Wood Duck Solar LLC
Responses to Siting Board Staff's Second Request for Information
Case No. 2024-00337

Wood Duck Solar LLC
Responses to Siting Board Staff's Second Request for Information
Case No. 2024-00337

Appendix

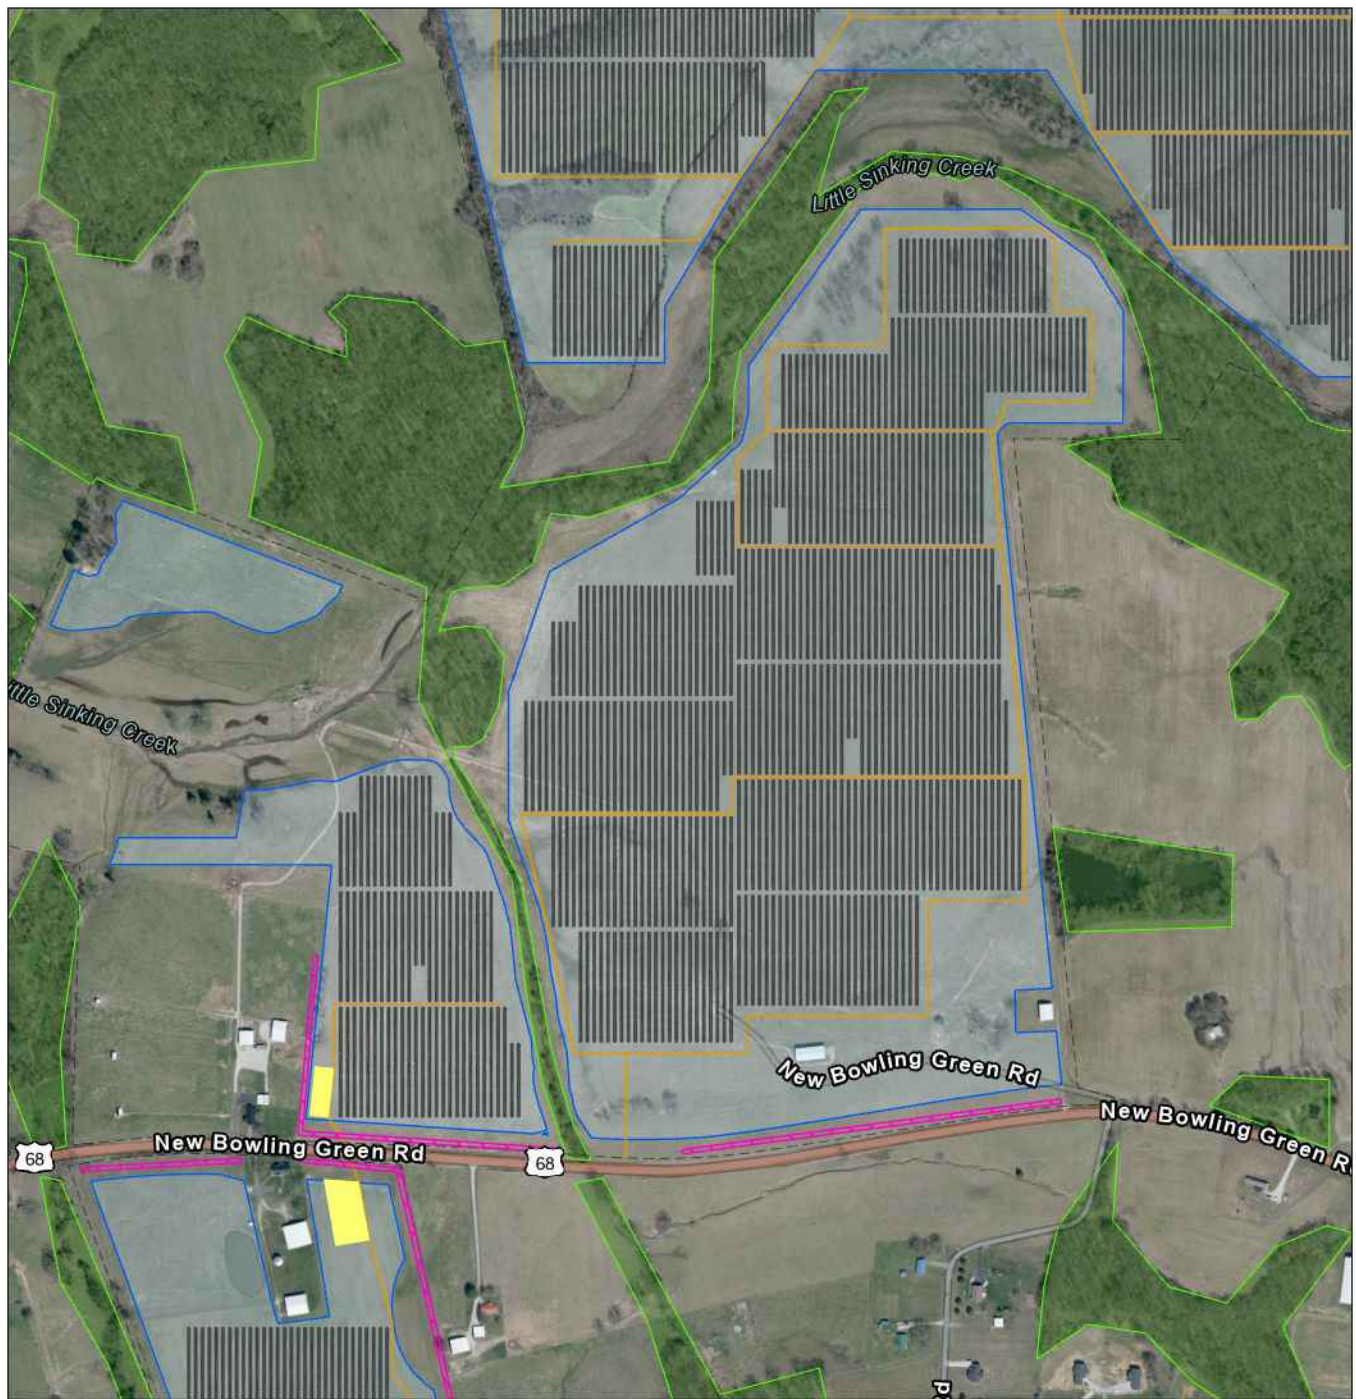
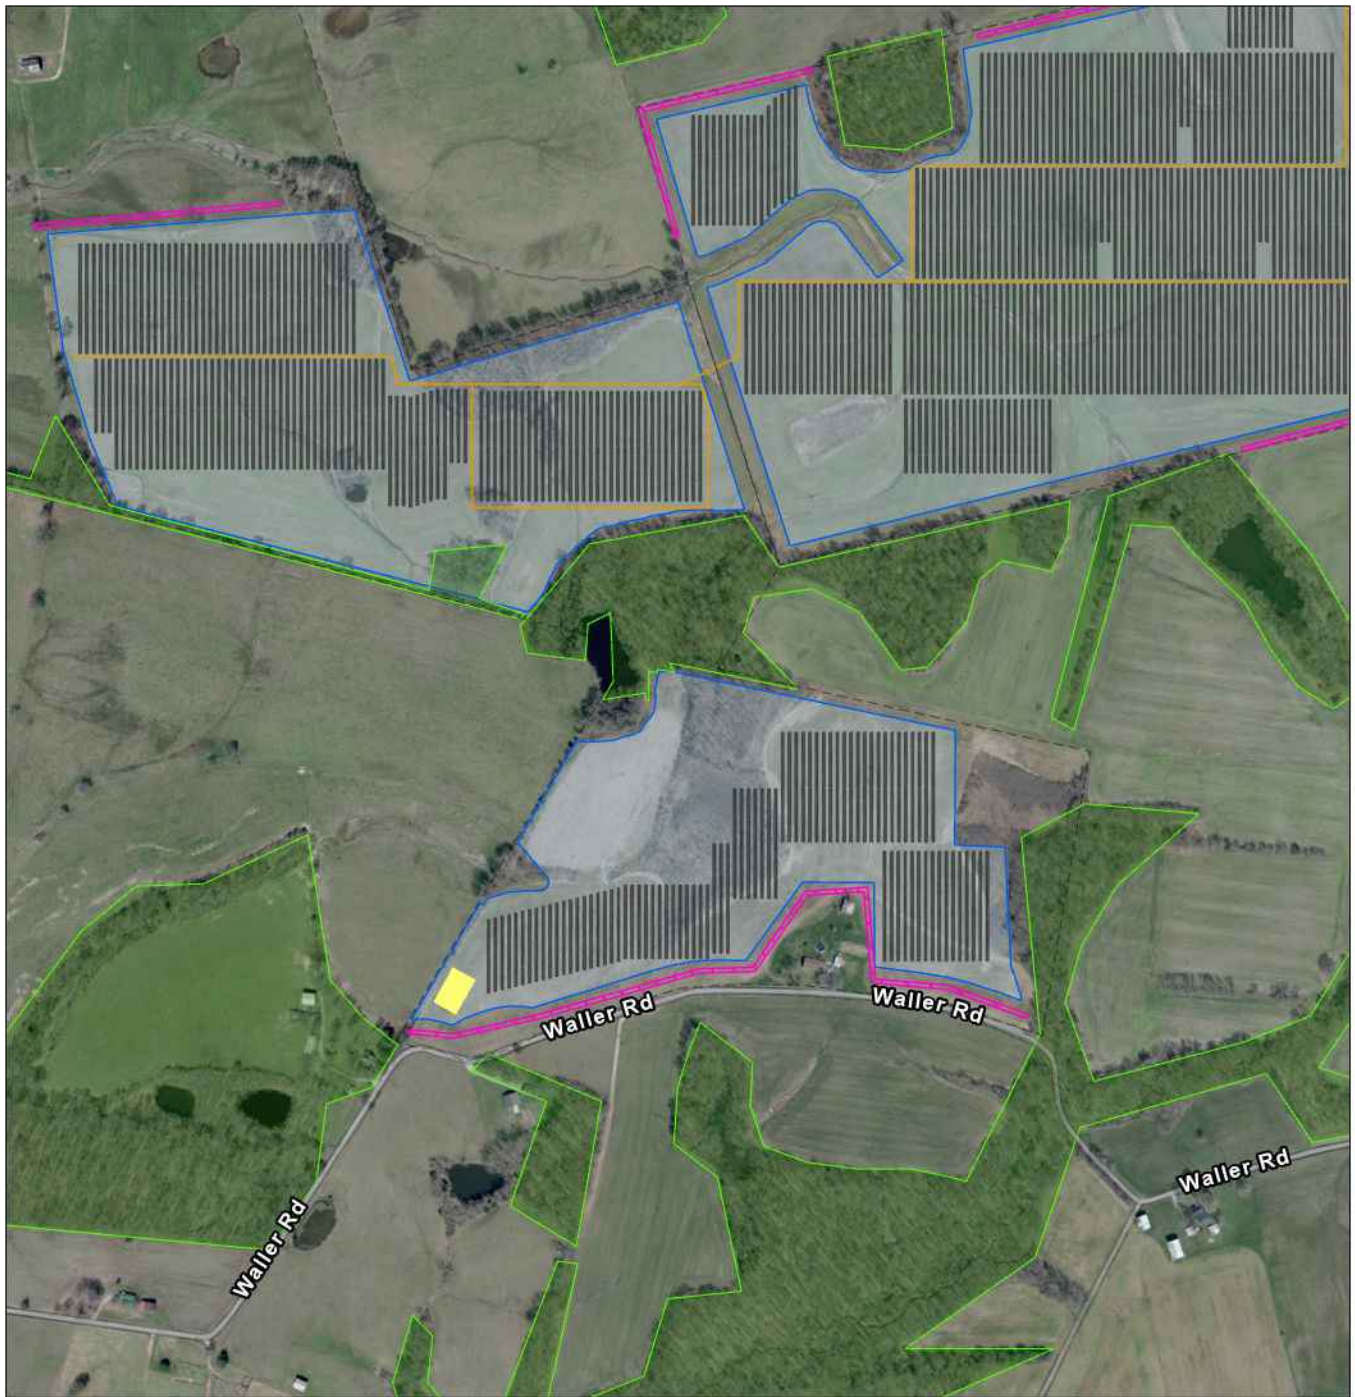
Refer to SAR, Attachment G, Appendix A, C202 Preliminary Landscape Plan map, and site visit. Logging has occurred on parcels where solar module Areas #18 and #21 are proposed and “existing buffer” as marked on the map has diminished. Provide a revised landscaping plan for areas that have been cleared by logging east of Millstown Rd and west of Park City-Bon Ayr Rd.

See attached. The revised landscaping plan was extended to add supplemental screening in areas that had cleared vegetation. The new length of proposed vegetative screening is now 45,353.92 feet (8.60 miles).

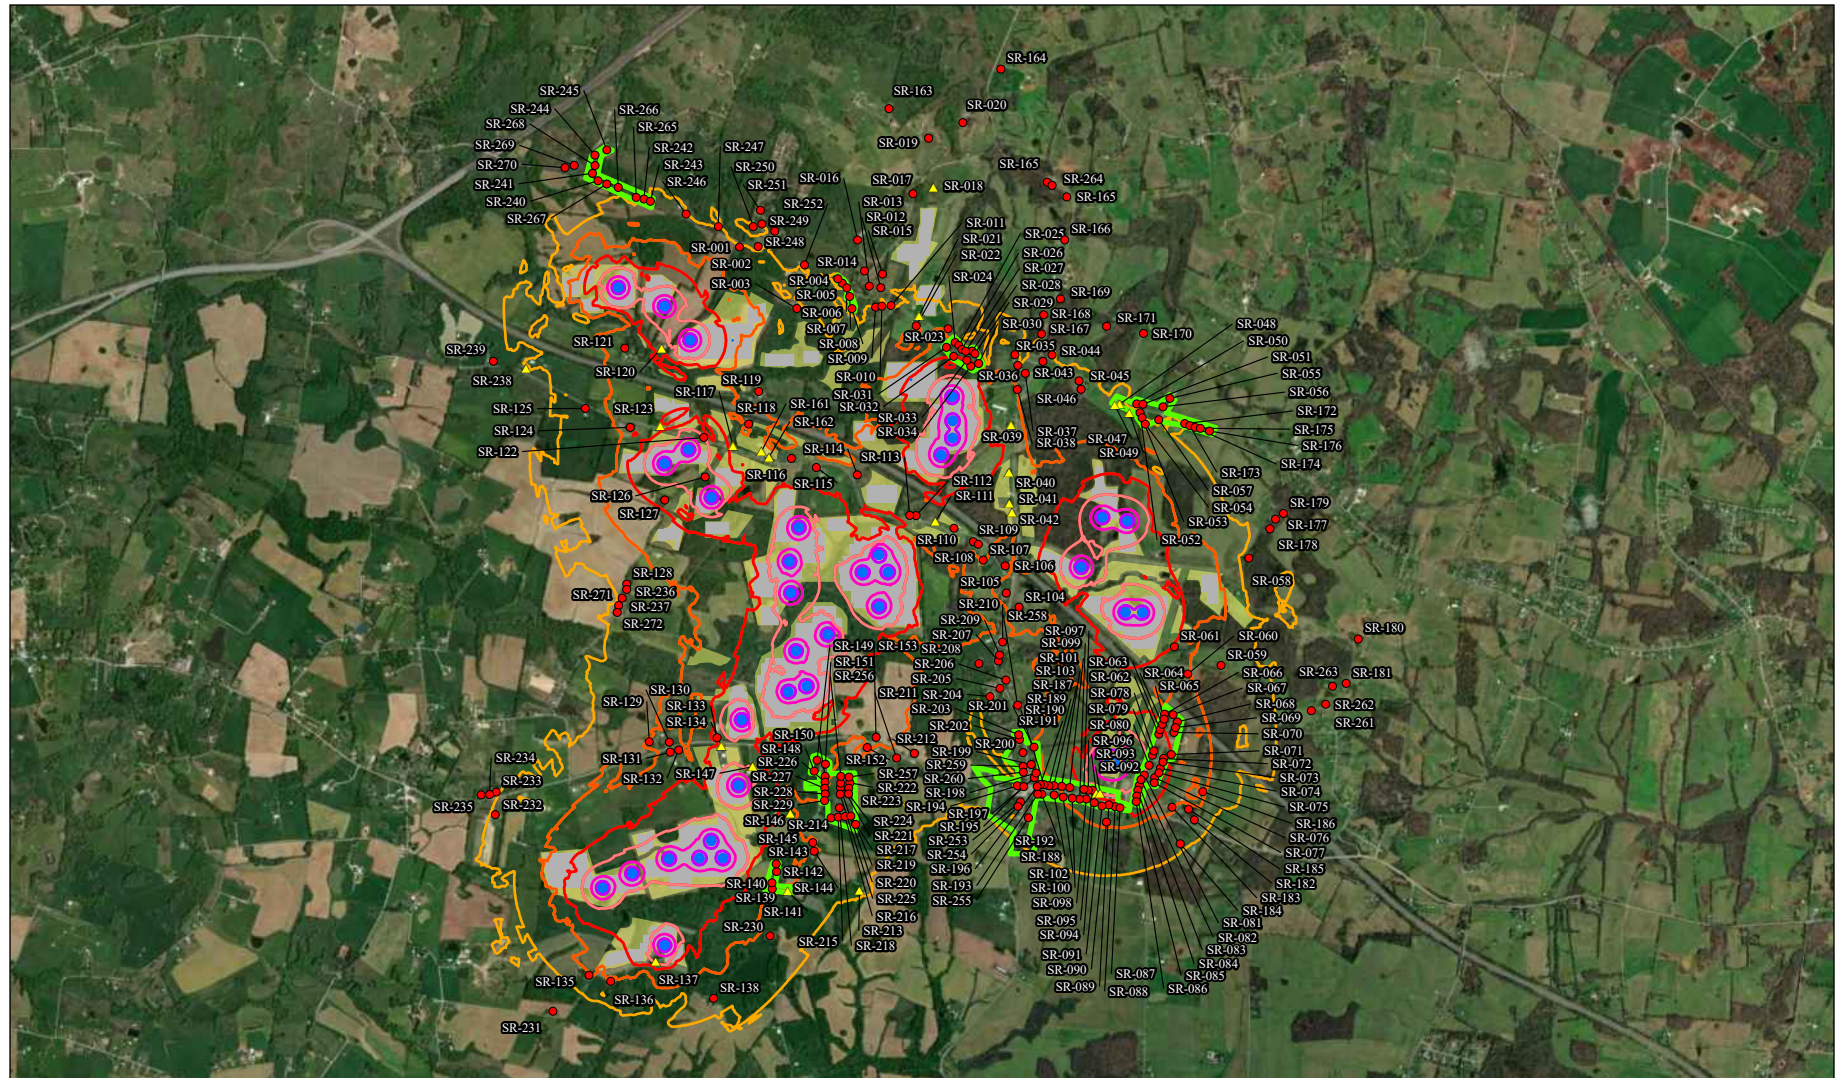
Refer to SAR, Attachment D, Sound Study, Figure 3 and Figure 4. Per the site visit, it was determined that some sound receptors (receptors) are incorrectly marked as participating or non-participating (i.e., SR-114 Woodlawn Church is marked as a participating structure and SR-137 is not marked as a participating structure). Provide:

- a. A revised Figure 4 – Operational Noise Contour map with corrected labels for participating/non-participating receptors.
- b. A list of the 266 noise sensitive receptors that indicates whether each receptor is participating or non-participating.

- a. See the attached map and table below.
- b. See the Response to Request No. 34(a).

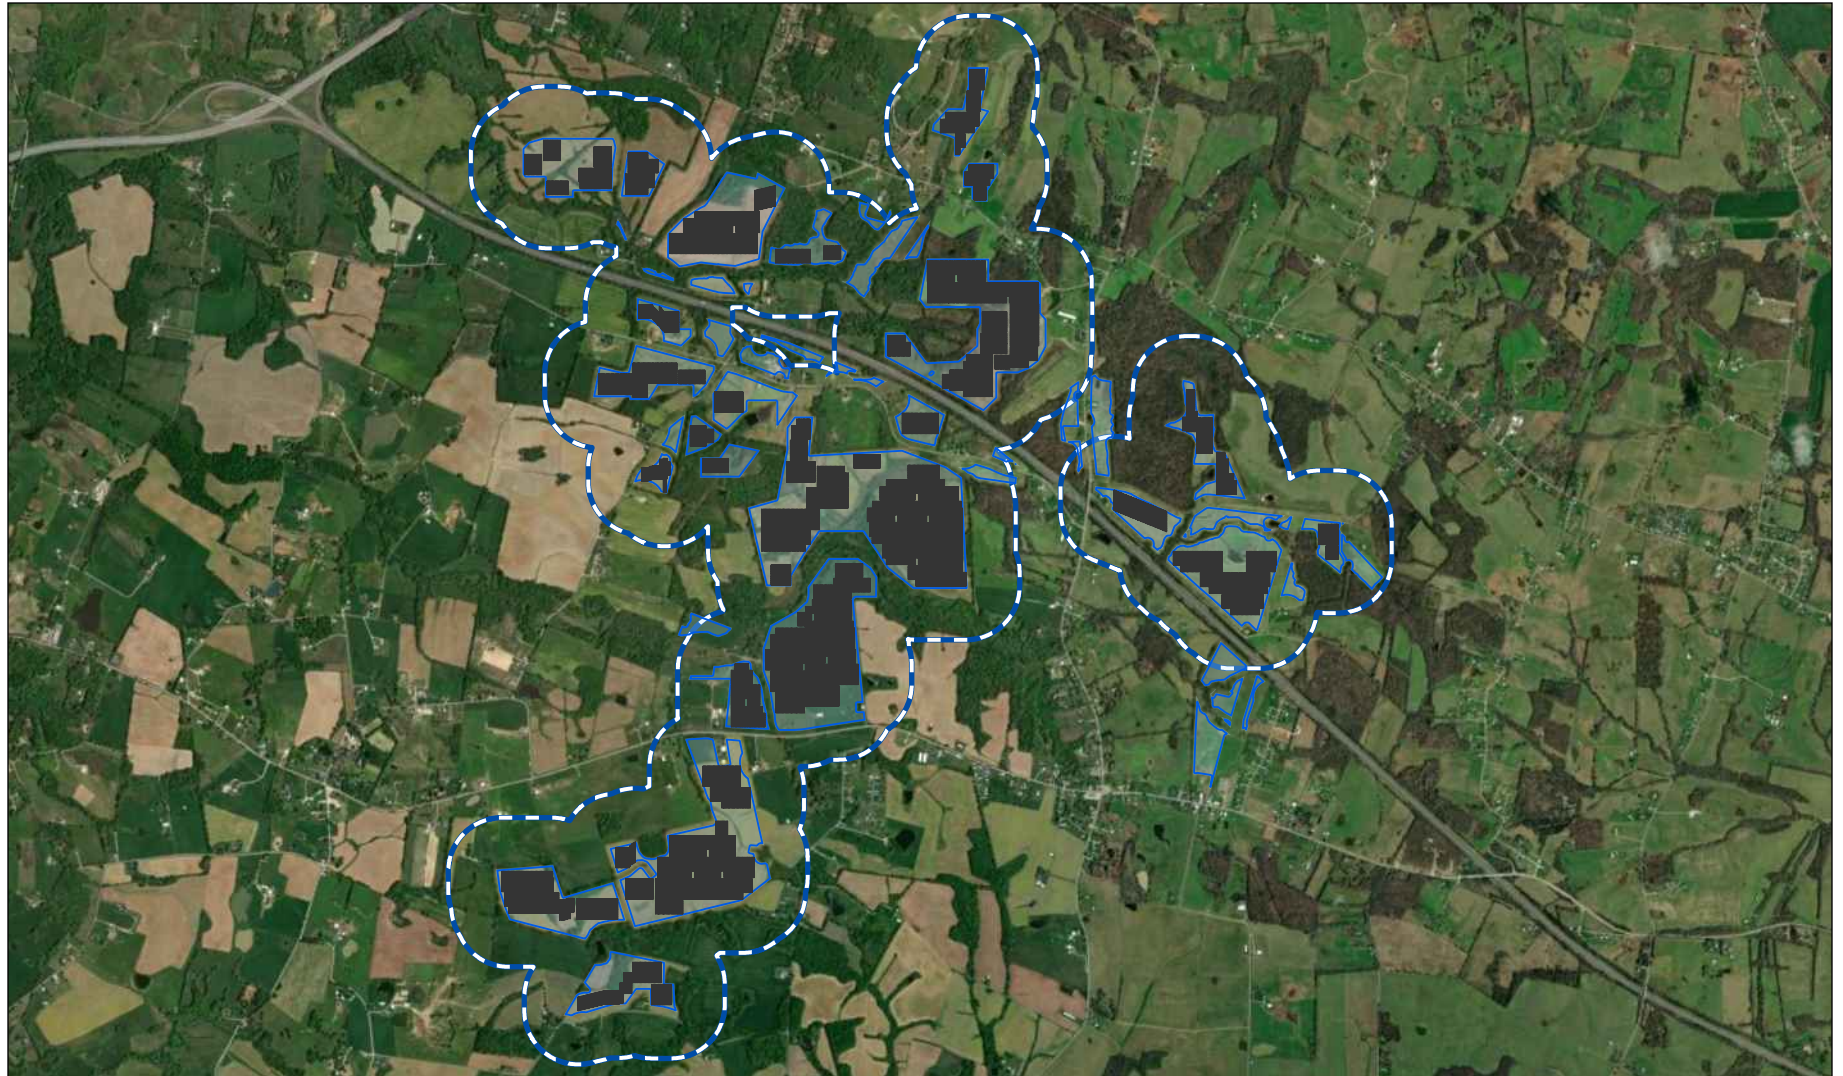
Refer to Wood Duck Solar's response to Staff's First Request, Item 87, the Construction Noise Buffer Attachment. Provide a revised Construction Noise Contour Map that includes noise sensitive receptors; participating structures; and Project components (PV layout, inverters, substation, fence line), with noise contours marked in 5 dBA increments from 40 dBA and greater indicating the "worst case" dBA Leg levels during construction.
